ADDENDUM NO. ONE (1)

AIRFIELD PAVEMENT REHABILITATION – PHASE 2

**LYNCHBURG REGIONAL AIRPORT
LYNCHBURG, VIRGINIA**

**AIP PROJECT NO. 3-51-0029-036 (PENDING)
DELTA PROJECT NO. 12121**

BASE MOUNTED FIXTURES - OPTIONAL PRECAST BASE DETAIL

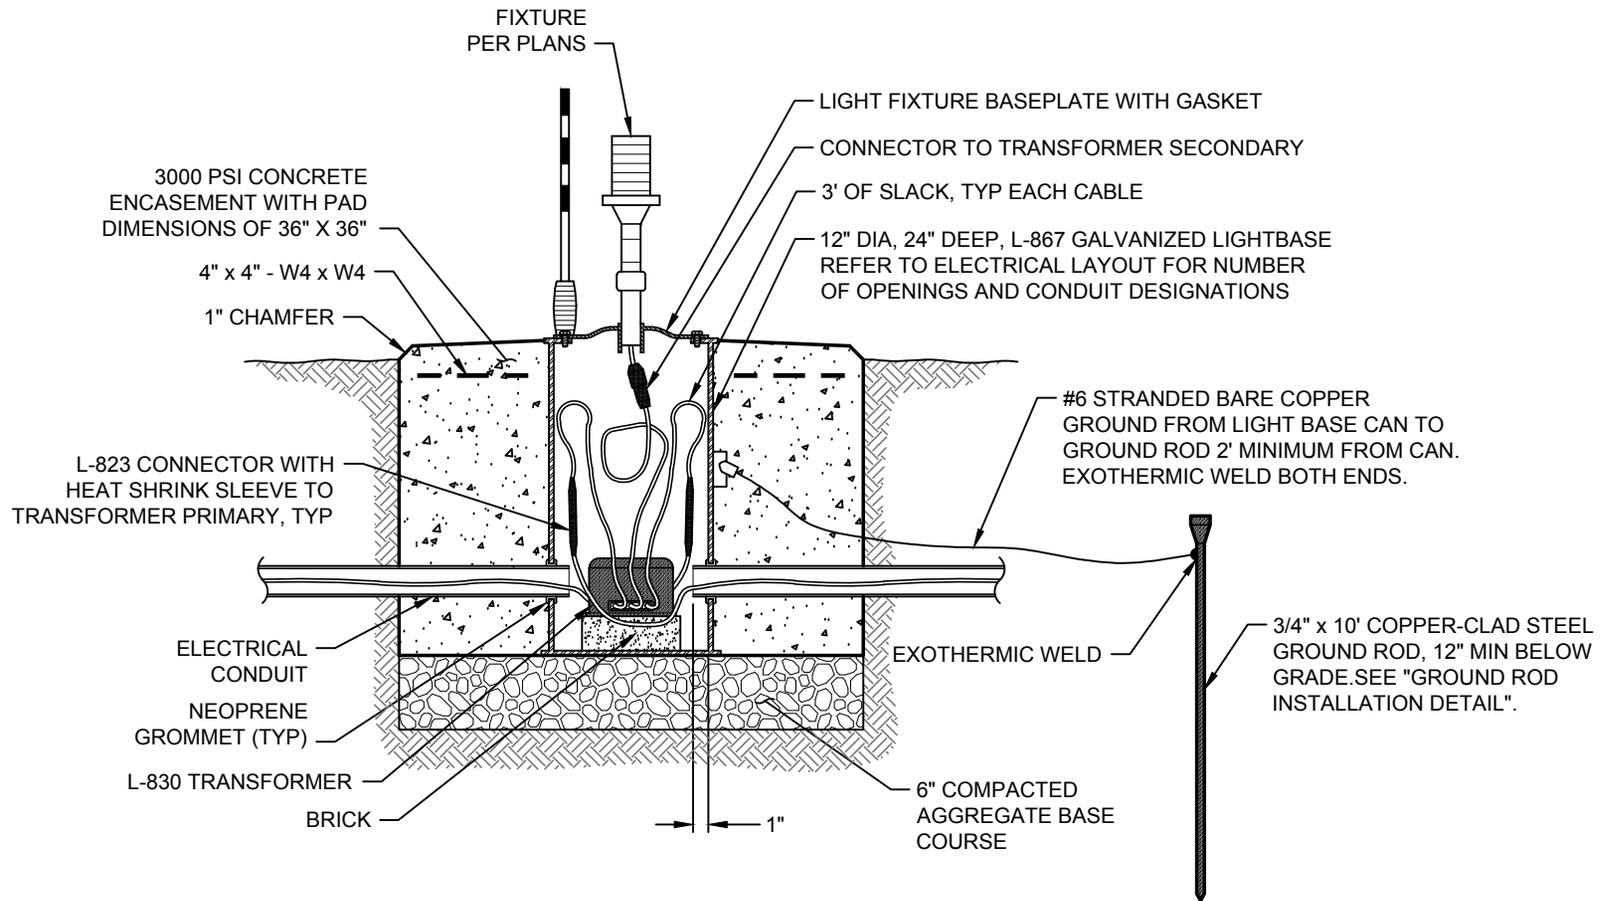
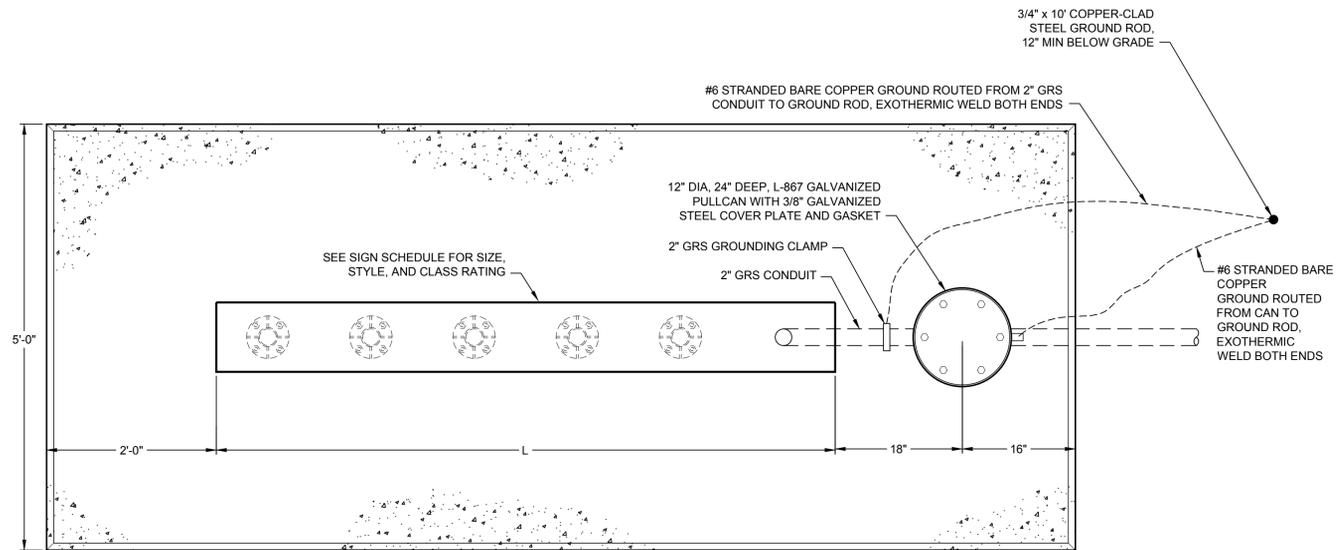
- 24. ADD** the attached “BASE MOUNTED FIXTURES – OPTIONAL PRECAST BASE DETAIL” of Addendum No. One (1).

1. PRECAST BASES MAY ONLY BE USED FOR FIXTURES LOCATED WITHIN THE RUNWAY 4-22 SAFETY AREA.
2. THE USE OF PRECAST BASES IS AT THE CONTRACTOR'S OPTION; NO ADDITIONAL PAYMENT WILL BE MADE FOR THE USE OF PRECAST BASES.

**AIRFIELD GUIDANCE SIGN (L.E.D.) DETAIL
(OPTIONAL PRECAST PAD)**

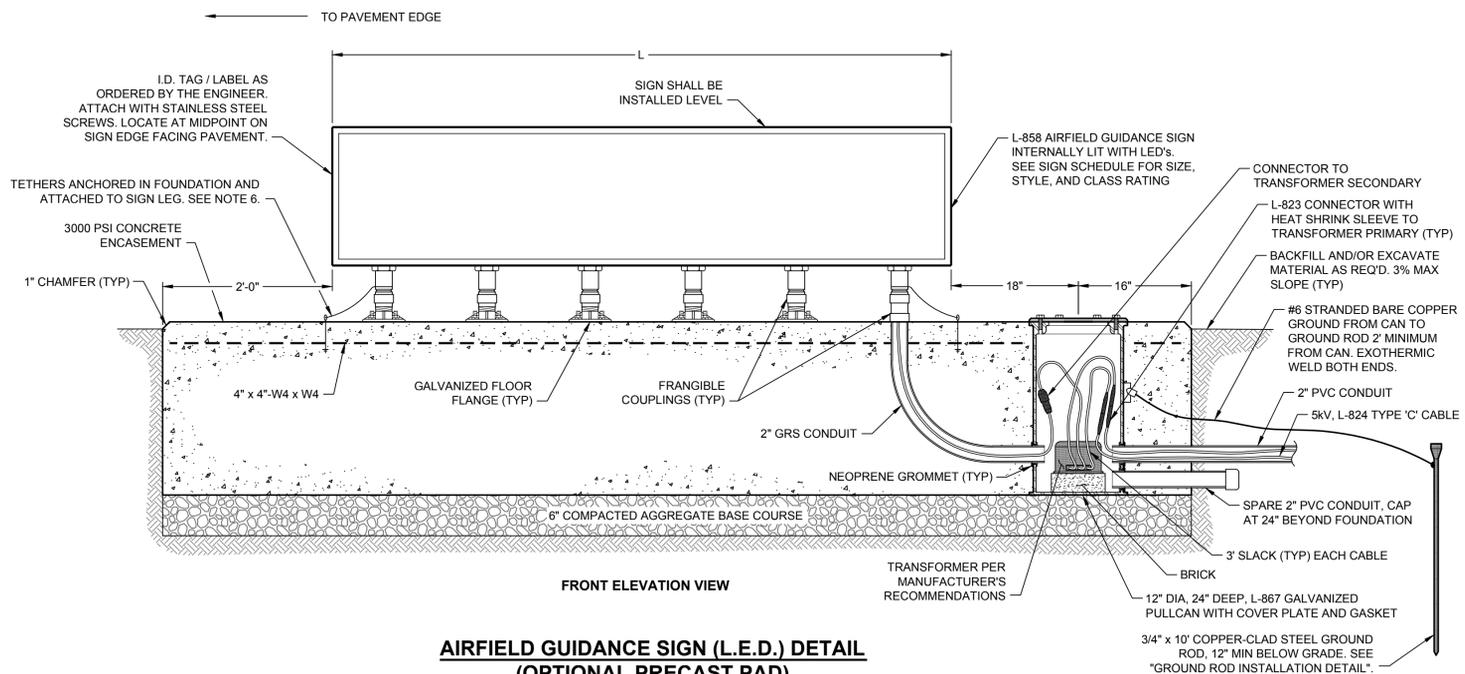
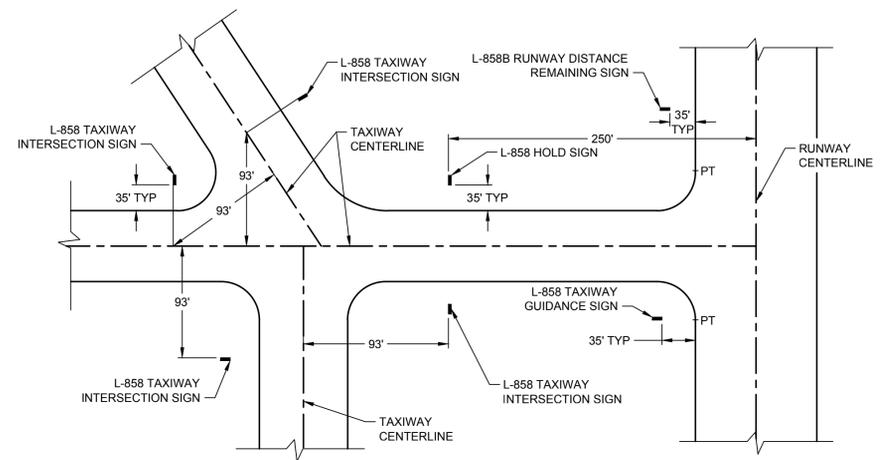
- 25. REPLACE** Sheet 56 of 69 with the attached Sheet 56 of 69 of Addendum No. One (1).

- NOTES:
1. PROVIDE A L-823 DISCONNECT PLUG AND RECEPTACLE IN THE FRANGIBLE COUPLING OF THE POWER LEG AS REQUIRED.
 2. ALL CONDUIT UNDER THE CONCRETE PAD IS INCIDENTAL TO THE COST OF THE AIRFIELD GUIDANCE SIGN.
 3. ORIENT THE INTERNAL POWER LUGS OF THE AIRFIELD GUIDANCE SIGN SO THAT THEY WILL BE CLOSEST TO THE LEG THROUGH WHICH THE POWER ENTERS THE SIGN HOUSING.
 4. THE #6 STRANDED BARE COPPER GROUND AND THE GROUND ROD ARE INCIDENTAL TO THE COST OF THE AIRFIELD GUIDANCE SIGN.
 5. CONTRACTOR TO COORDINATE DEPTH OF PAD WITH MANUFACTURER'S RECOMMENDED ANCHOR BOLTS.
 6. SINGLE MODULE SIGN REQUIRES ONE TETHER. MULTIPLE MODULE SIGN IN CONTINUOUS FRAME MUST USE TETHER AT BOTH ENDS.
 7. PRECAST PADS MAY ONLY BE USED FOR SIGNS LOCATED WITHIN THE RUNWAY 4-22 SAFETY AREA.
 8. THE USE OF PRECAST PADS IS AT THE CONTRACTOR'S OPTION; NO ADDITIONAL PAYMENT WILL BE MADE FOR THE USE OF PRECAST PADS.

AIRFIELD PAVEMENT REHABILITATION-PHASE 2		AIP NO. 3-51-0029-036 (PENDING)	JOB NO. 12121
DRAINAGE PROFILES		DRAWN BY: DWS	SHEET 61
LYNCHBURG REGIONAL AIRPORT		DESIGNED BY: TJZ	OF 69
SCALE: HORZ. 1" = 30' VERT. 1" = 3'		DATE: MAY 2013

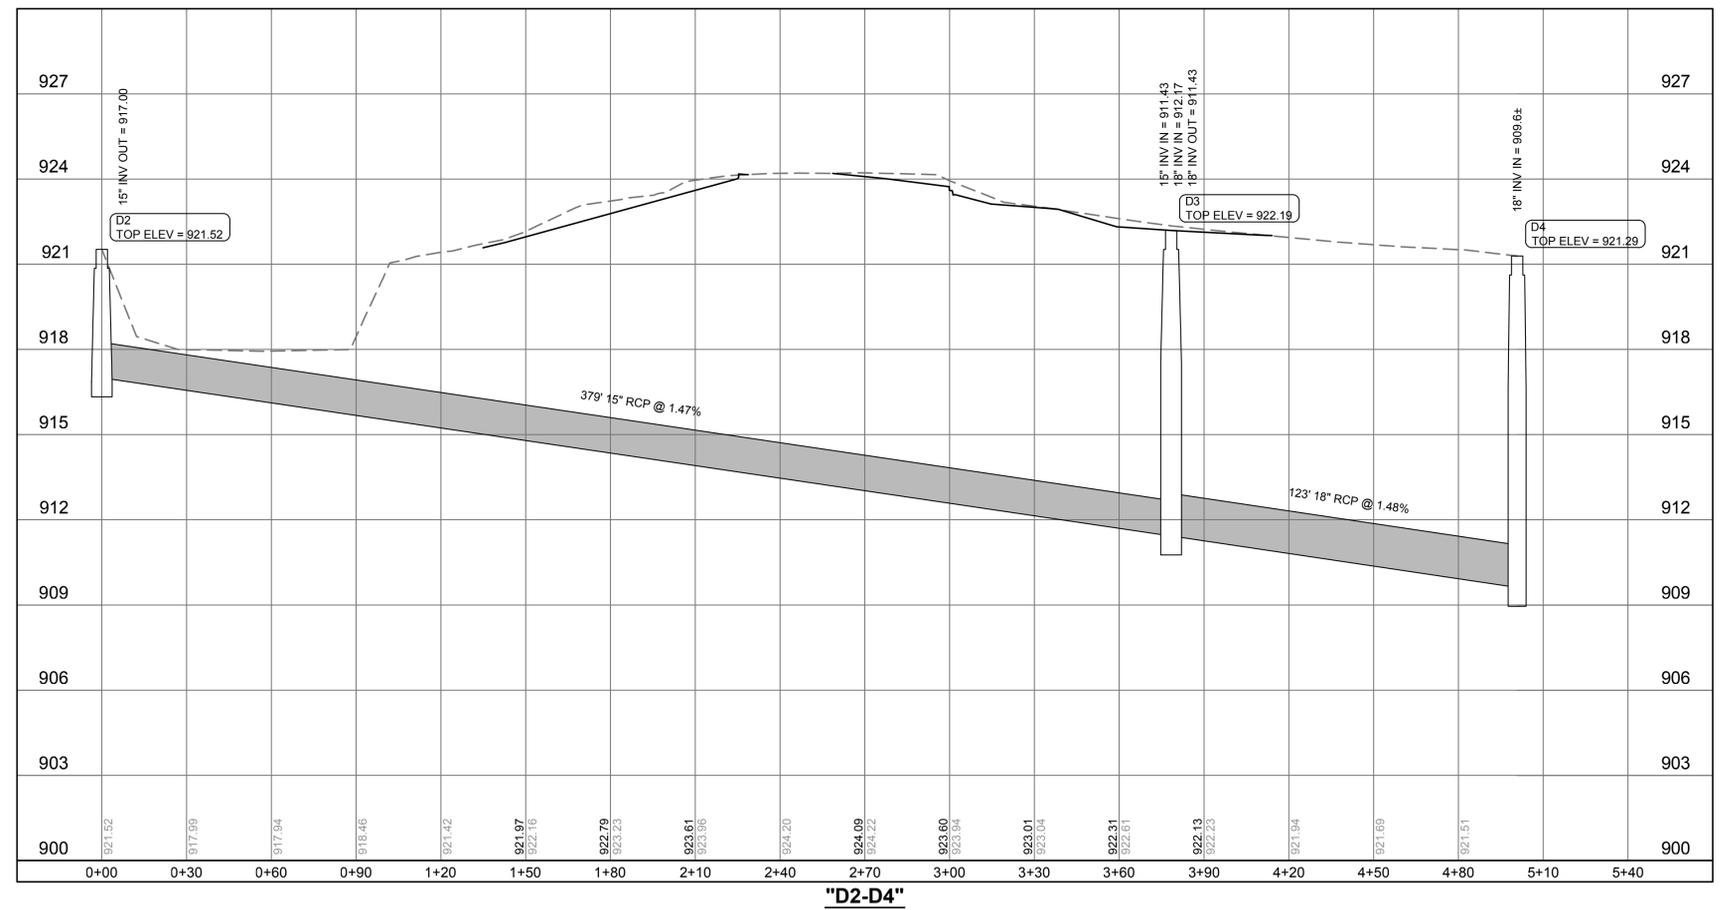
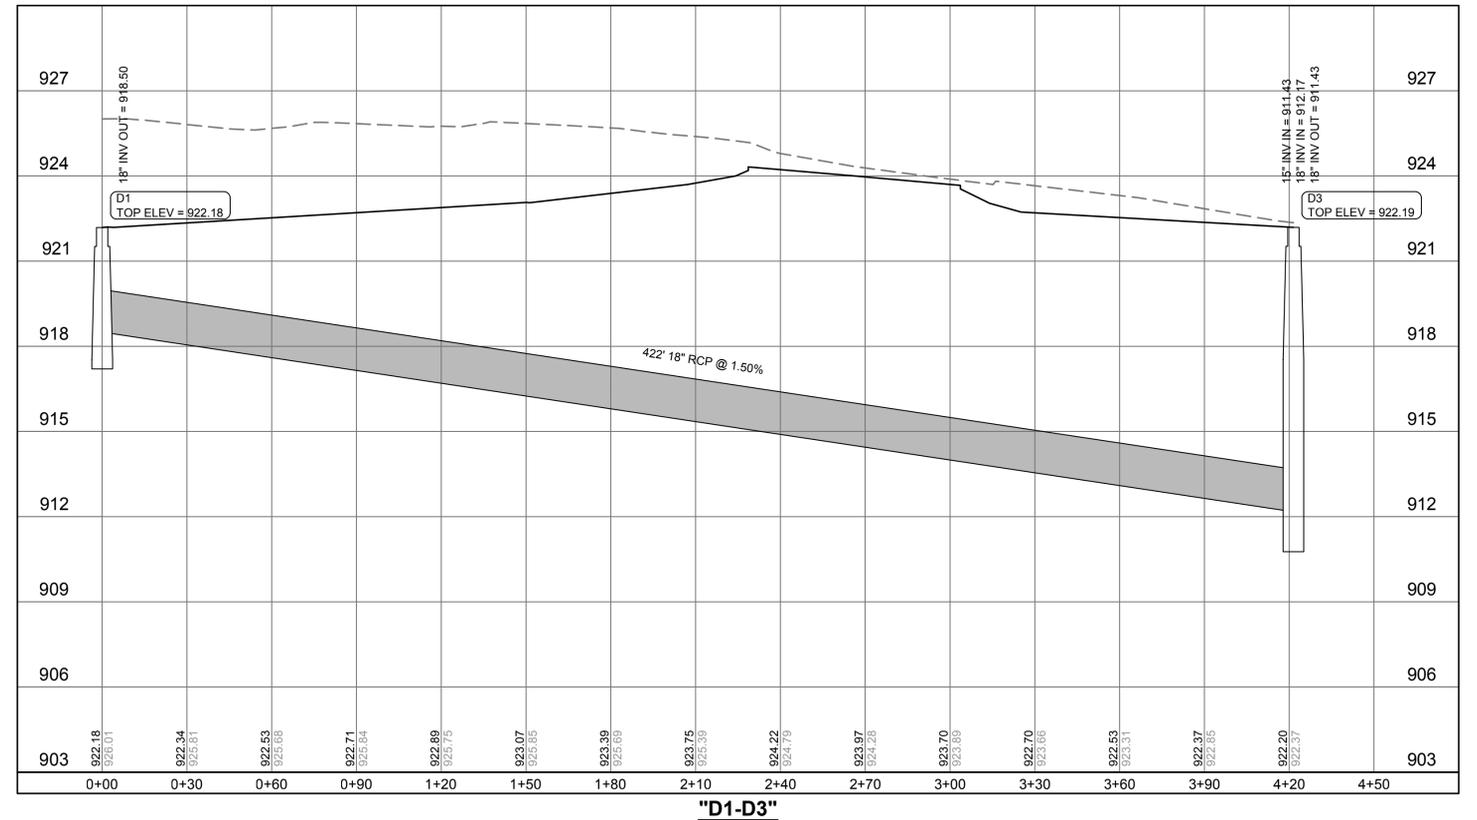
- 26. REPLACE** Sheet 61 of 69 with the attached Sheet 61 of 69 of Addendum No. One (1).
